19 November 2019

**RE: Peer Review of Visual Impact Review prepared by MHBC Planning Limited  
Capital Paving Inc. Shantz Station Pit  
Our File: 19554**

WND Associates Limited has been retained by the Township of Woolwich to conduct a peer review of the submitted Visual Impact Review (the 'VIR') prepared by MHBC Planning Limited (dated May 2019) and submitted in support of applications to amend the Official Plan and Zoning By-law to permit the establishment of a new aggregate extraction operation. Applications have also been submitted under the Ontario Aggregate Resources Act to permit the proposed extraction.

**Figure 2 View of 1224 Maryhill Road from frontage of St. Boniface Church**

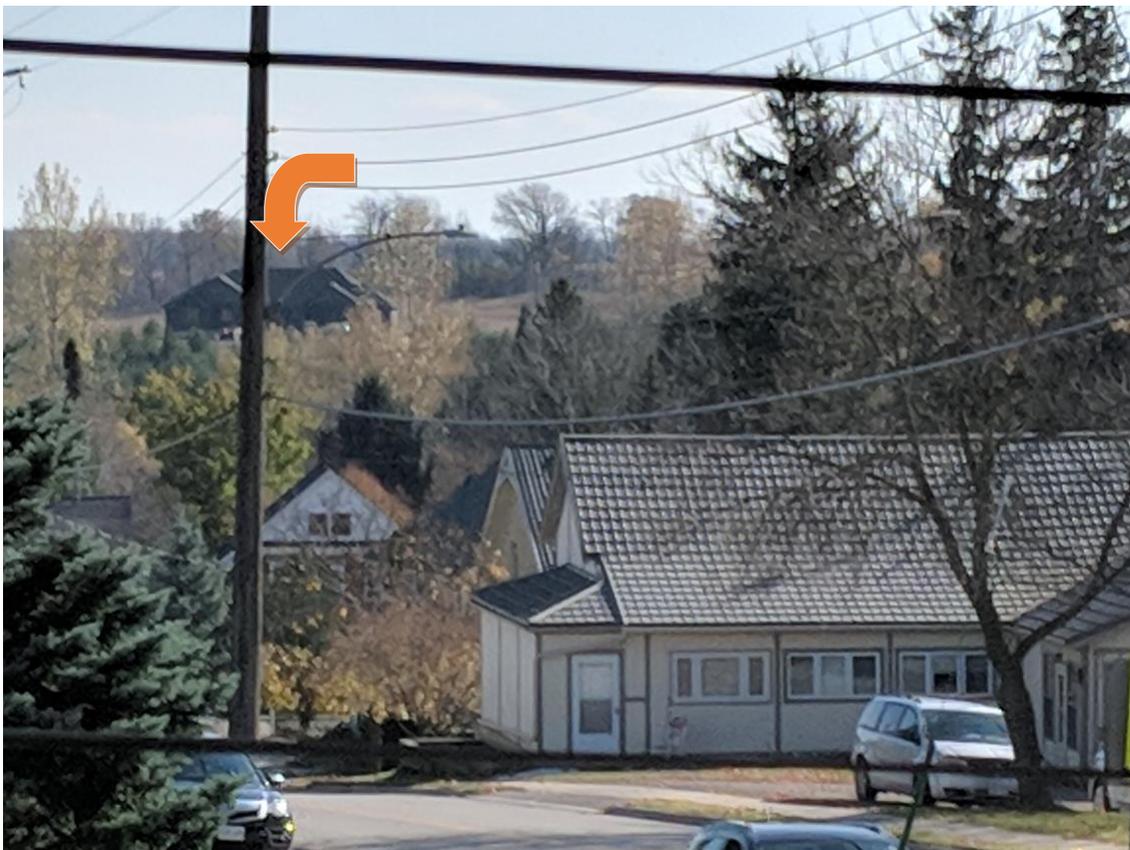
Figure 2 below demonstrates the view of the residence at 1224 Maryhill Road from St. Boniface Church taken during the WND Associates site visit.

*WND Associates has reviewed the Proposed Mitigation Plan, and is of the opinion that the proposed berm heights, setbacks and planting are appropriate to adequately address the potential for visual impacts from Village View Road and Maryhill Road for*

*the residences identified within the submitted VIR. An addendum or update to the VIR should be provided to evaluate the potential for visual impact to 1224 Maryhill Road and whether further mitigation measures are required.*
